**Planning &
Environment**

**Tahmoor North Mine
Modification to Subsidence Area
(DA 67/98 MOD 4)**

Environmental Assessment Report
Section 75W of the Environmental Planning and Assessment Act 1979

Figure 5: Predicted subsidence

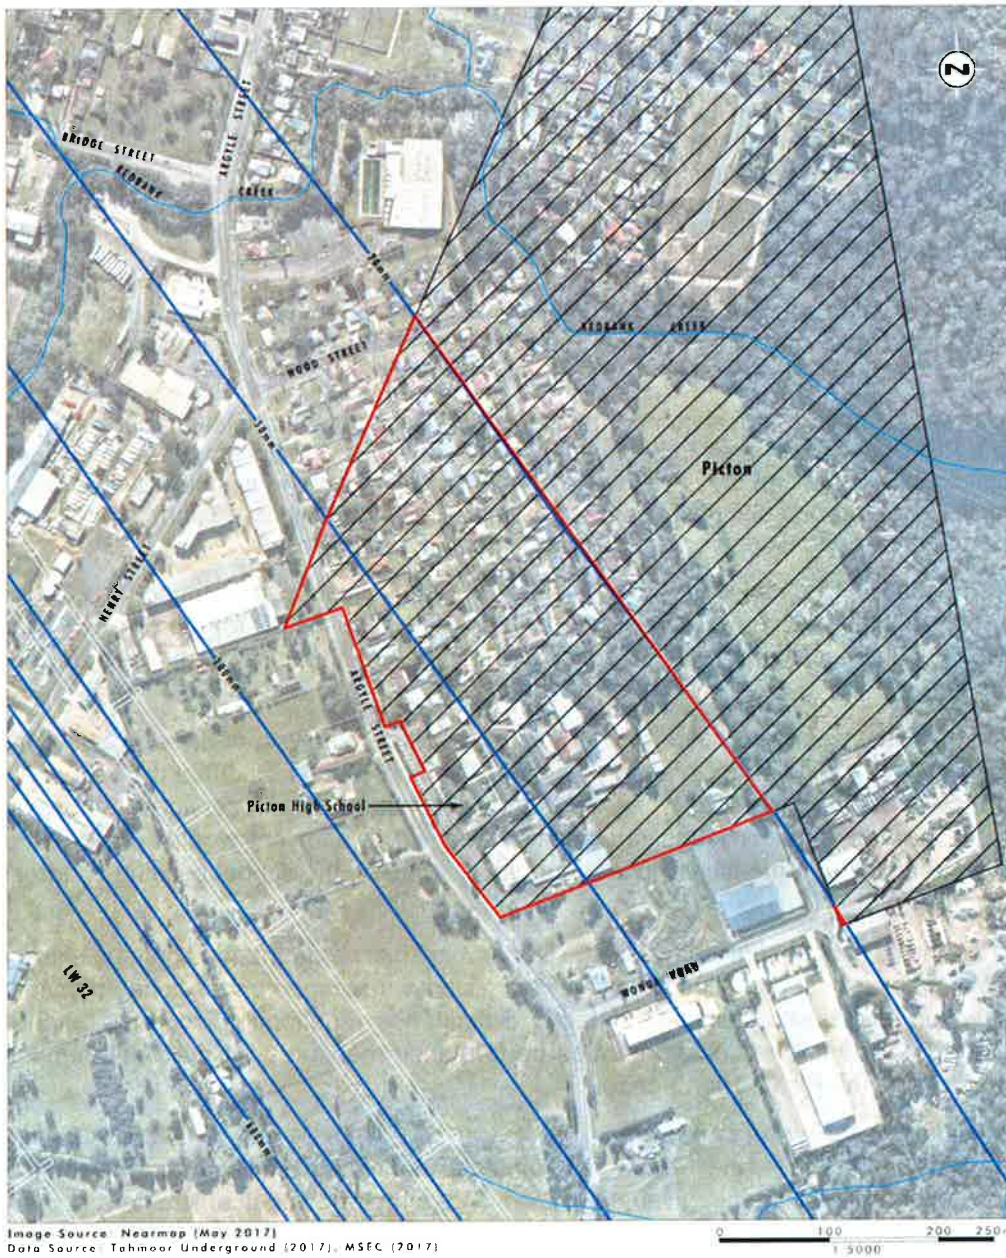
The Subsidence Assessment indicates that subsidence in the modification area would be relatively minor, ranging from 20 to 70 millimetres (mm) vertical subsidence. A summary of maximum predicted

subsidence parameters, both in the modification area and the broader mining area for Longwalls 31-37, is provided in **Table 2** below, and the predicted subsidence contours are shown in **Figure 5**.
